UNITED STATES PATENT AND TRADEMARK OFFICE

Office Action Summary

10/644,465

Michael Thaler

APPENDIX A

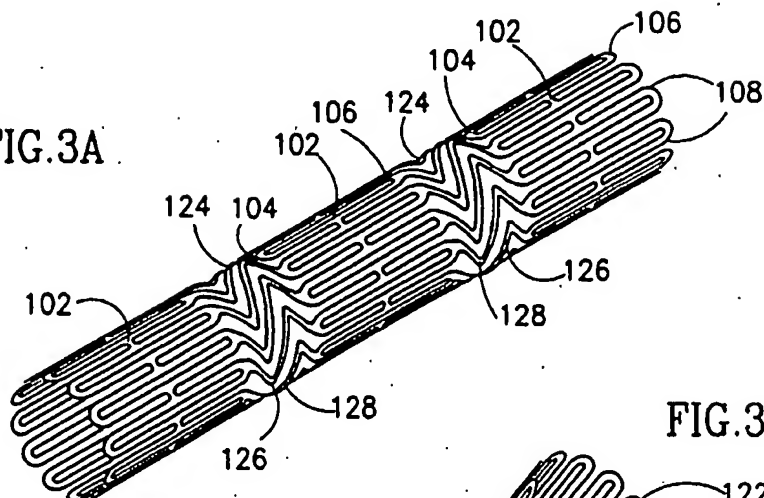
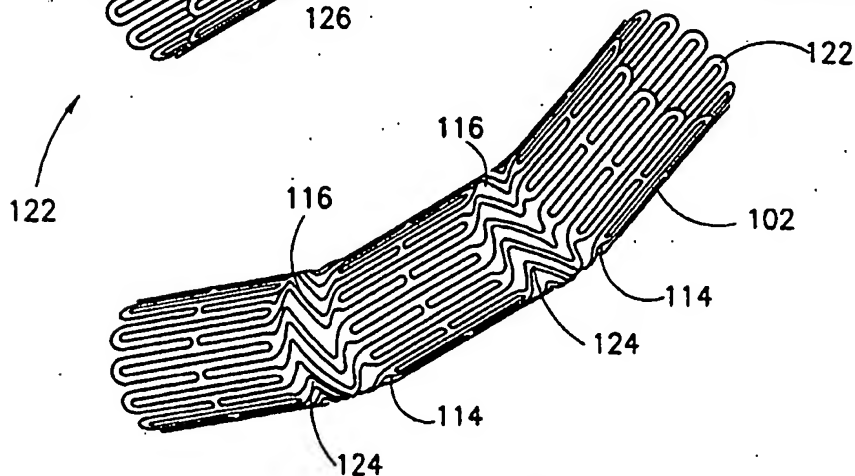
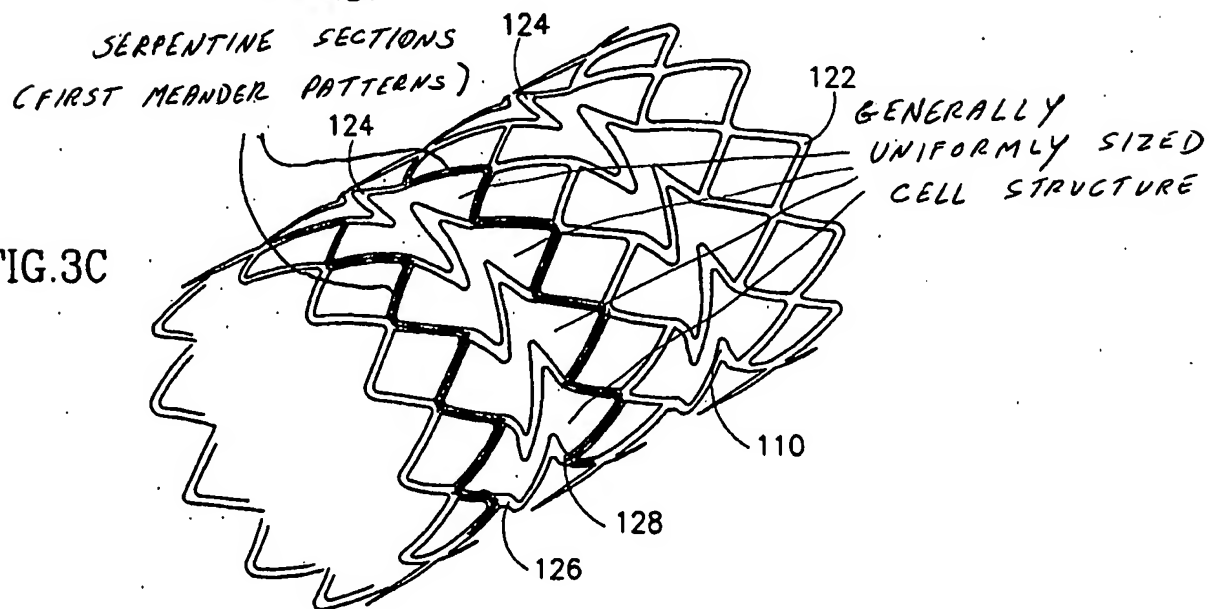
Claims 42, 44-49, 51, 57-60, 63-69 and 72 are rejected under 35 U.S.C. 102(e) as anticipated by or, in the alternative, under 35 U.S.C. 103(a) as obvious over Pinchasik et al. (5,449,373). As to claim 42, Pinchasik et al., in figures 3A-3C, disclose a plurality of continuous serpentine sections (as shown in the attached appendix A), a plurality of flexible connectors 124 forming a generally uniformly sized cell structure (as shown in appendix A), each of the connectors being elongatable in a bend of a lumen to maintain a generally uniformly sized cell structure in the bend after expansion (the above identified cells will inherently still be generally uniformly sized in the bend since any difference between the cell sizes will be relatively small, particularly in a small bend. Alternatively, it would have been obvious that the cells will still be generally uniformly sized in the bend when the bend is small since any effect the bend would have on the cell size would be small due to the smallness of the bend. As to claim 46, the top end of the Pinchasik et al. connectors are open, closed, open and closed along the longitudinal axis of the stent from the left to the right as seen in figures 3A-3C. As

to claim 57, Pinchasik et al., in figures 3A-3C, disclose first meander patterns and second meander patterns as shown in the attached appendixes A and B.
